**Re: ODOARDI – Vacant Lot
22 Nethermont Ave. – New House Construction
Tax ID: Section 122.16 – Block 4 – Lot 7**

This letter accompanies a revision to the plans, in response to the draft resolution received from the Planning Board Staff and Town Consulting Engineer.

Site Plan and Tree Removal Permit Approvals for

Odoardi [19-039]

STORMWATER / SITE PLAN DETAILS

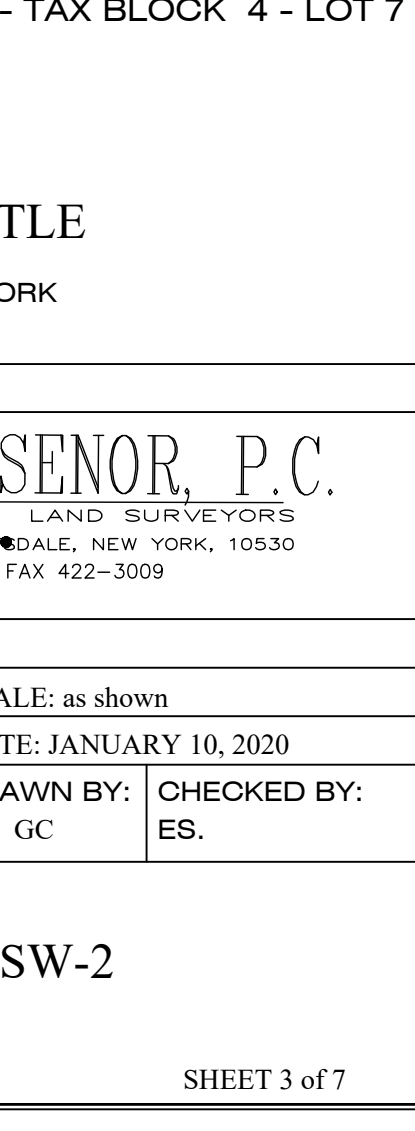
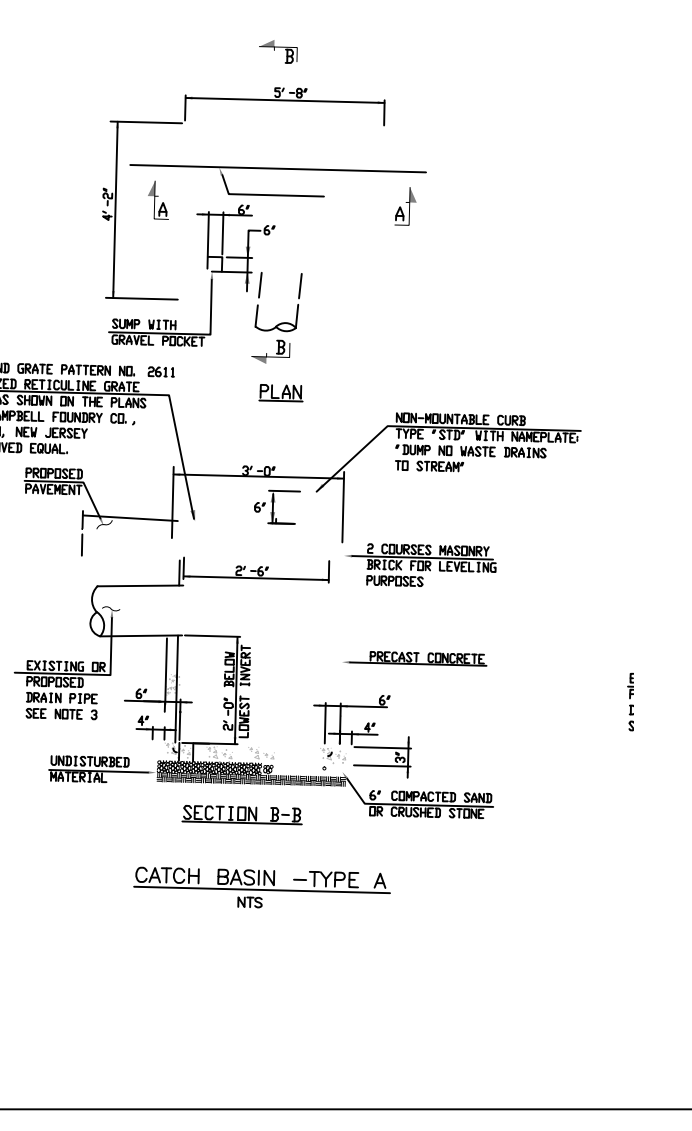
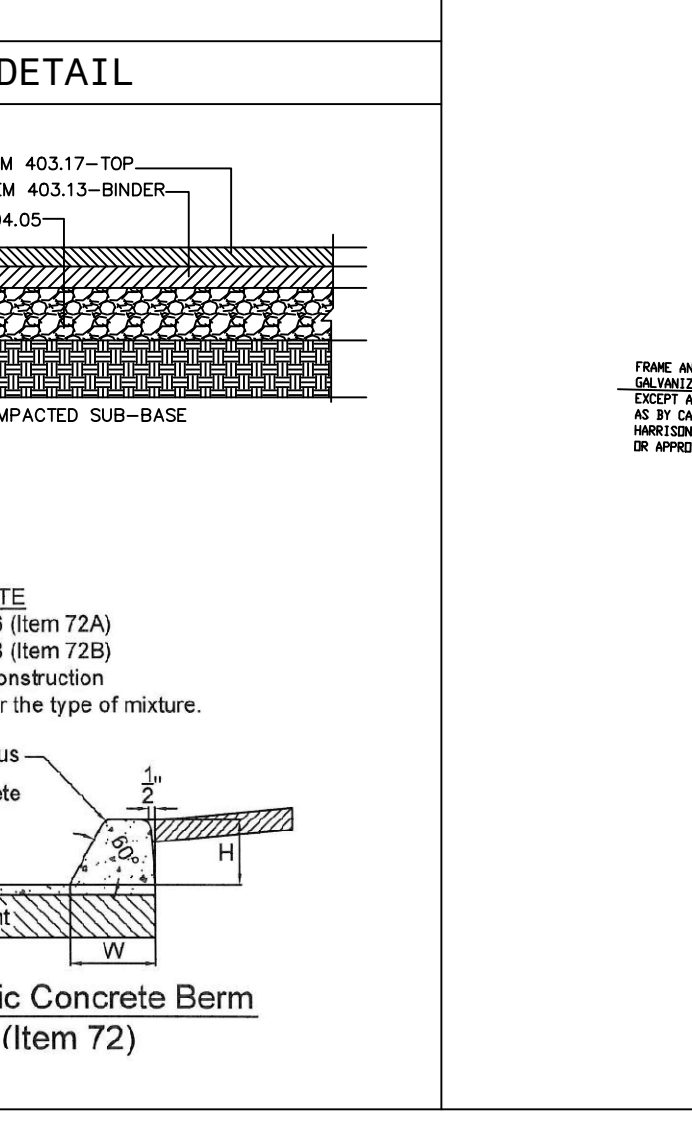
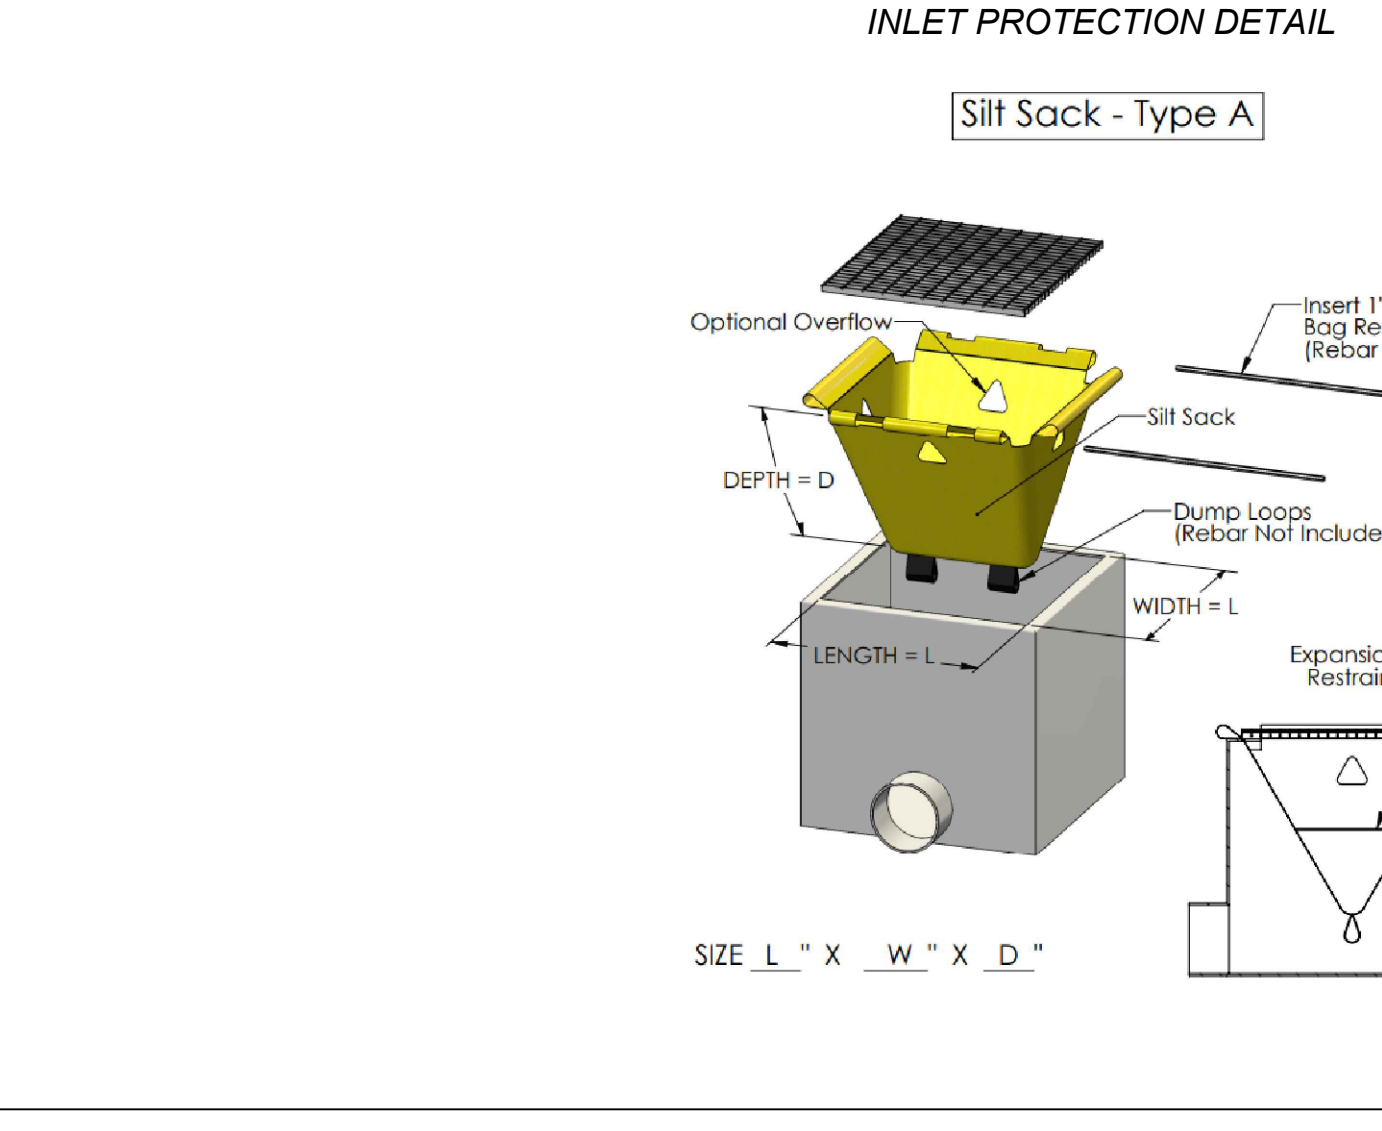
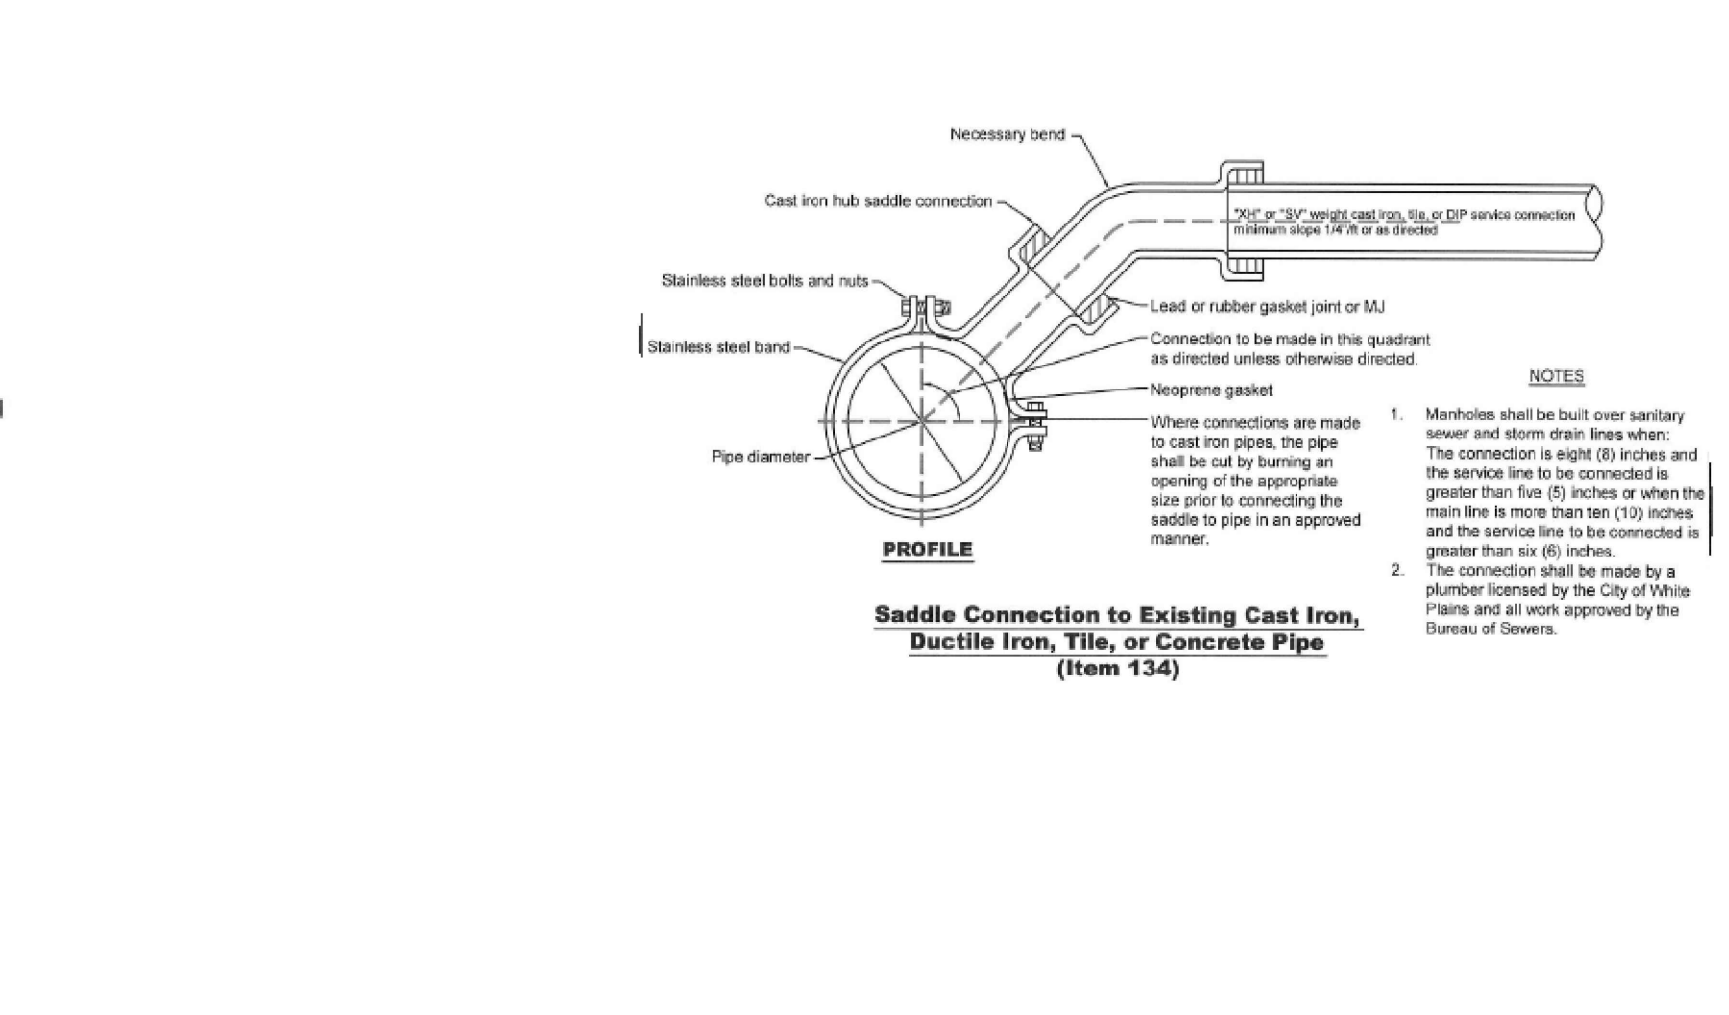
- _____ 6. The Trench Restoration Detail shall be revised to comply with North Castle Highway Department Standards to the satisfaction of the Town Engineer. The detail shall indicate k-crete backfill for the full depth of the trench. All saw cut lines shall be tack coated and all joints crack seal. The water service curb stop shall be located on the plan.

- _____ 7. The driveway detail shall be revised to illustrate an 18 foot maximum curb cut width to the satisfaction of the Town Engineer.

- _____ 9. The proposed trench drain detail shall include dimensions and note that it is suitable for H-20 Vehicle Loading to the satisfaction of the Town Engineer.

- _____ 18. As shown, it appears the Trench Restoration Detail, Stone Retaining Wall Detail, and Impervious Surface Area Detail on Drawing SW-2 did not plot correctly. These details shall be illustrated on the plan to the satisfaction of the Town Engineer.

Trench Restoration detail on the stormwater and site plan details sheet 3 of 7 notes full depth K-Crete in paved areas

Driveway detail now shows an 18 foot curb cut maximum on sheet 3 of 7.

Proposed trench drain detail now includes dimensions and notes H20 Loading.

Sheet SW-2 has been re printed to show all of the required details.

SD-1

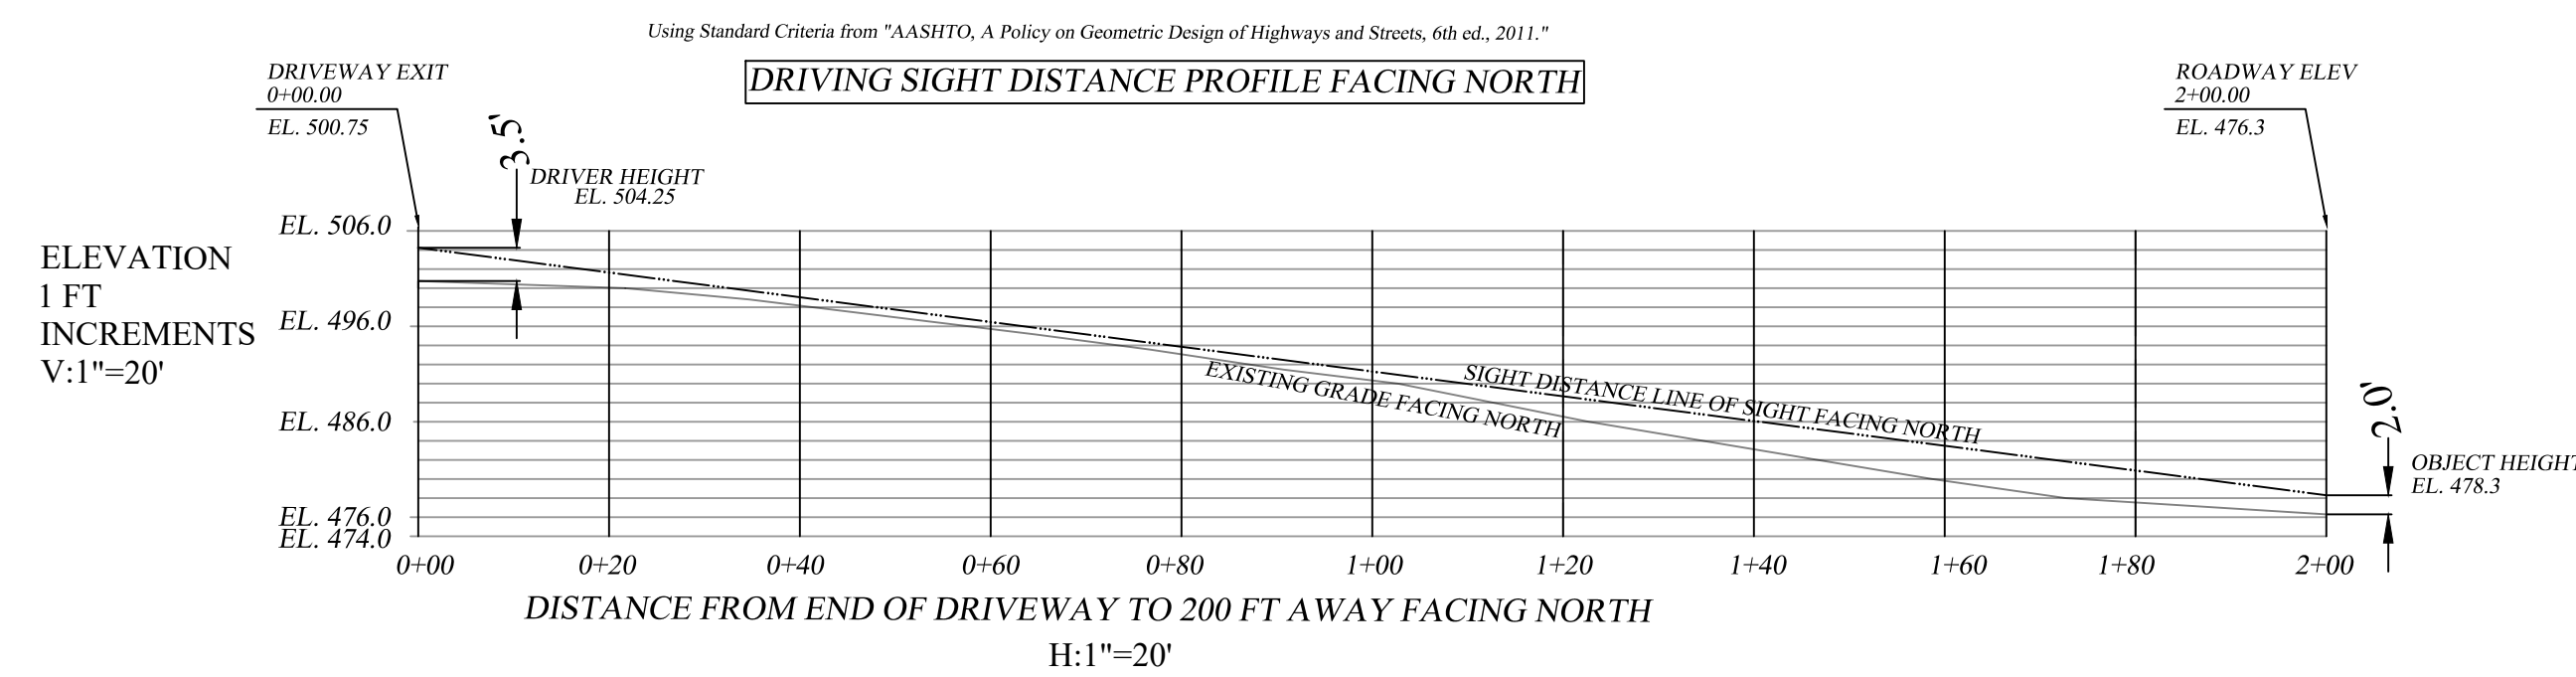
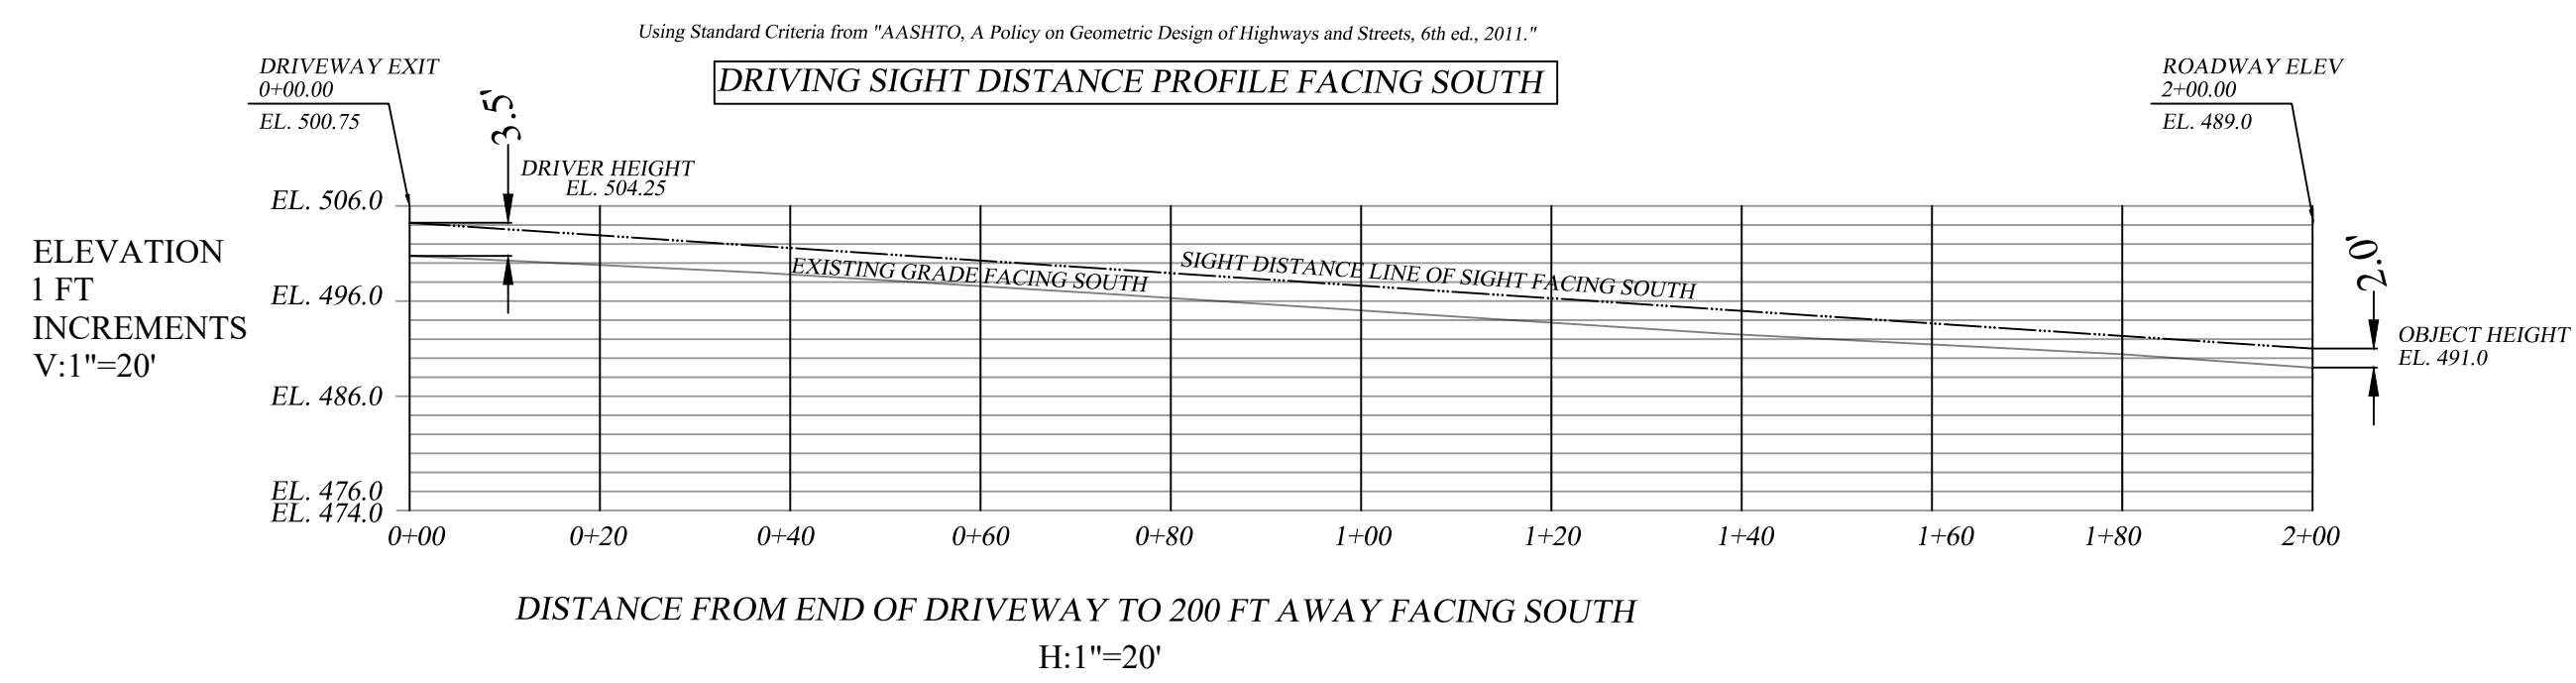
_____ 1. The applicant shall provide a sight distance exhibit demonstrating 200' of sight distance available to the left and right of the driveway to the satisfaction of the Town Engineer. The plan and profiles shall establish the driver's eye set 3.5 feet above grade, 14 feet back from the edge of the road with a line of sight to an object in the road 2 feet above grade. The elevations shall use the same datum as the submitted plans and correspond to the grades on the profiles. As shown, the plan does not provide adequate sight distance to the north. The sight line profiles are missed label and shall be corrected to the satisfaction of the Town Engineer.

See sight distance analysis plan sheet 5 of 7
